**WASILLA PLANNING COMMISSION
RESOLUTION SERIAL NO. 21-07**

**A RESOLUTION OF THE WASILLA PLANNING COMMISSION APPROVING
CONDITIONAL USE PERMIT NO. 21-05 TO BUILD A 5,748 SQUARE FOOT THREE
BEARS MARKET WITH A 10-PUMP GAS STATION, LOCATED ON UNIT 1, STEAM
COMMONS CONDOMINIUM PLAT.**

EXHIBIT A
Wasilla Planning Commission Resolution 21-07
FINDINGS OF FACT – Section 16.16.050, General Approval Criteria

TITLE: OVERALL SITE PLAN

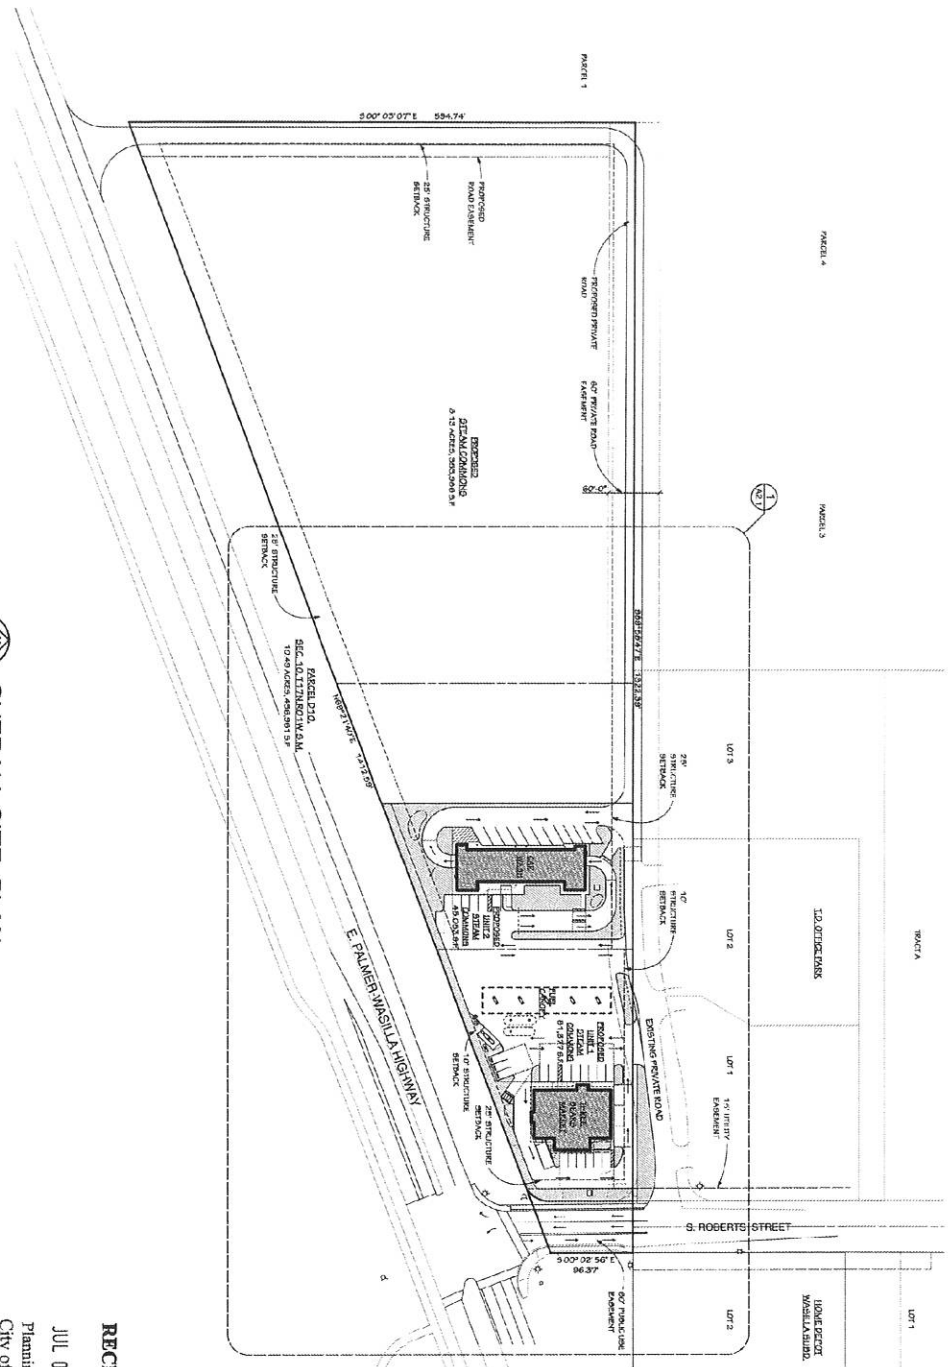
2. Provide survey for Unit 1, Steam Common Condominium showing corners set/located dated within last six months (WMC 16.08.015(C)(3)).
3. Submit updated site plan prior to construction that provides on-site drainage and retention/detention areas required in WMC 16.05.015(C)(13).

Finding: This criterion is not met since the site plan did not provide adequate on-site retention/detention. However, with a condition of approval is proposed requiring submittal of a revised site plan providing this information.

LANDSCAPE PLAN
L103
SHEET 4

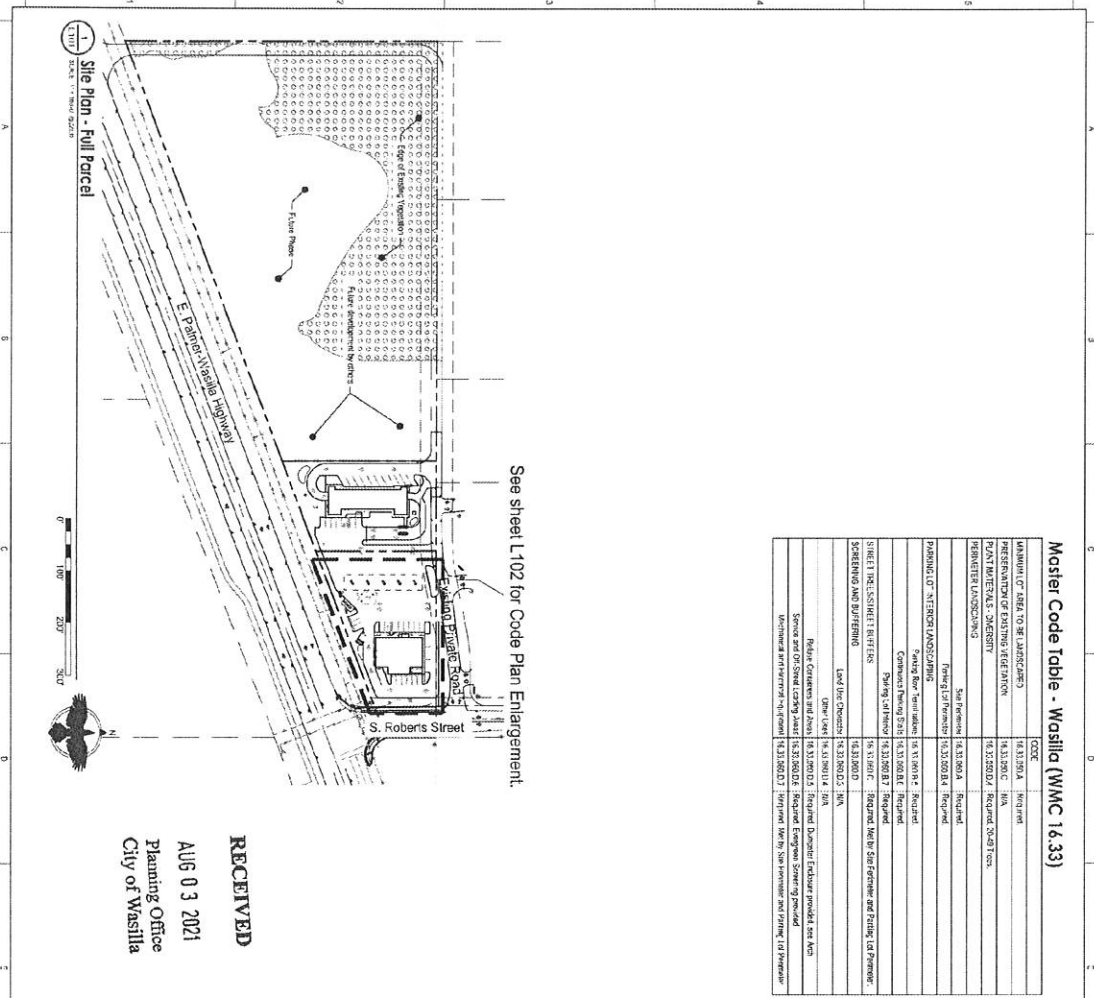
4. Submit required clearing/grading plan (WMC 16.08.015(C)(13)).
5. Submit updated landscape plan prior to construction that: (a) labels the dimension and area of the landscaped areas; (b) adds 6' tall opaque fence to screen RV dump and propane with fence and shrubs from right-of-way; and (c) adds the plantings required in WMC 16.33.060(F) to the grassed area abutting the northeast corner of the building.

1 C-STORE EAST
1/8" = 1'-0"

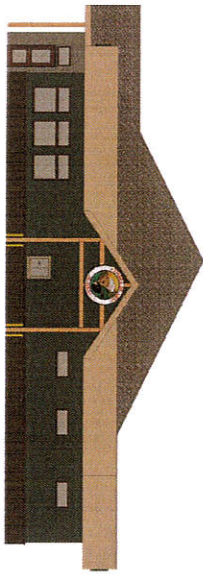
7. Submit revised building elevation that incorporates architectural detail to the substantially blank façade on the east side of building (facing Roberts Street) that are included on the west (entrance) and south sides of the building (WMC 16.33.060(F)).

Finding: This criterion is not met as proposed. The east side of the building facing S. Roberts Street is a substantially blank façade. WMC 16.33.060(F) requires that a minimum of 50 percent of a blank façade of a building facing the street more than 35' wide must be "broken up" with landscaping that includes trees, shrubs, perennial flowers, and boulders. However, parking is proposed against the building wall that prevents the required plantings to visually break up the wall surface.

To address this requirement, staff is proposing a condition of approval that requires the submittal of revised building elevations for the east side of the building (facing S. Roberts Street) that incorporates architectural details from the west (entrance) and south sides of the building. A condition is also proposed that requires the landscape plan be revised to supplement the proposed grass area abutting the northeast corner of the building with the landscaping required in WMC 16.33.060(F).
